August 8, 2006

**Re: CooperVision Site # V00175-8
Sub-Slab Depressurization System (Amended Work Plan); May 18, 2006
Village of Scottsville, Monroe County**

Subject: CooperVision – **Sub-Slab Depressurization System (Amended Work Plan)**
711 North Road
Scottsville, NY

SUB-SLAB DEPRESSURIZATION
SYSTEM DETAIL

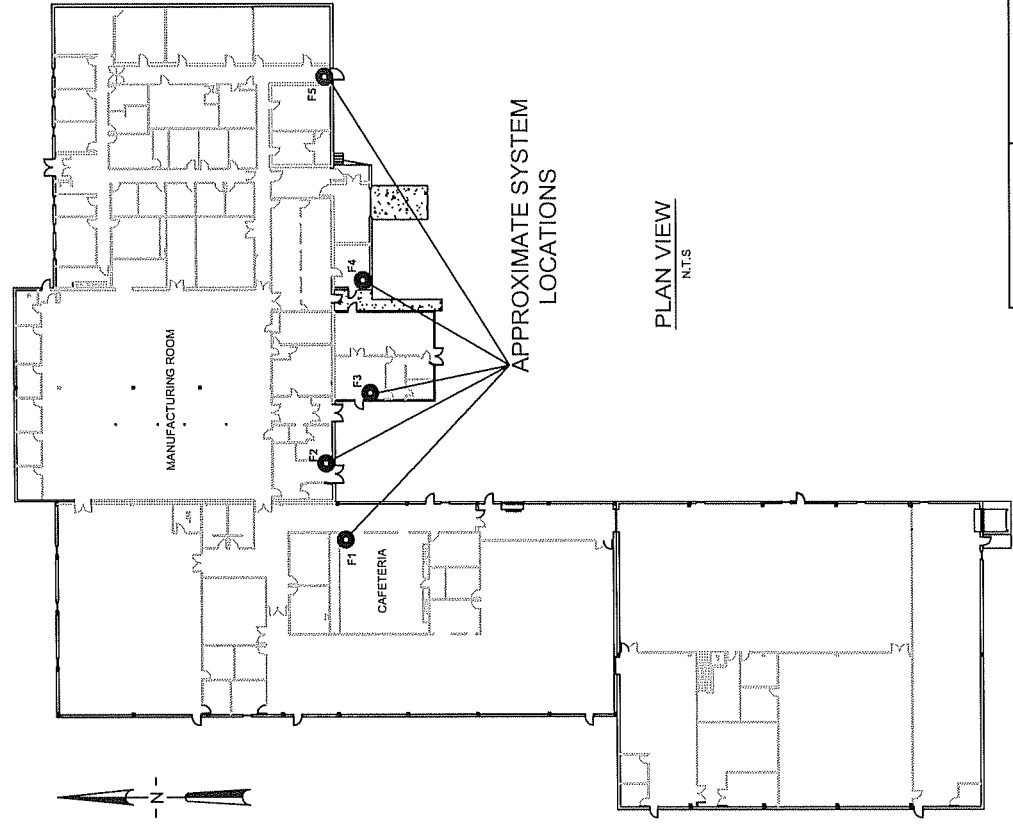
1. The initial performance of the system will be evaluated against the following objectives:
 - A minimum differential pressure of 0.002 inches of water between the ambient and sub-slab measurements at approximately 20-ft from each of the five fan locations shown on Figure 2 of the IRM Work Plan.

- A continuous minimum differential pressure of 0.002 inches of water between the ambient and sub-slab measurements between locations F1 and F5.
2. If necessary, additional activities will be completed to the extent practicable if the performance objectives are not achieved with the five proposed locations. These activities may include installation of additional sub-slab depressurization systems, alternate system configuration, indoor and outdoor air sampling, or other appropriate action approved by NYSDEC and the New York State Department of Health (NYSDOH).
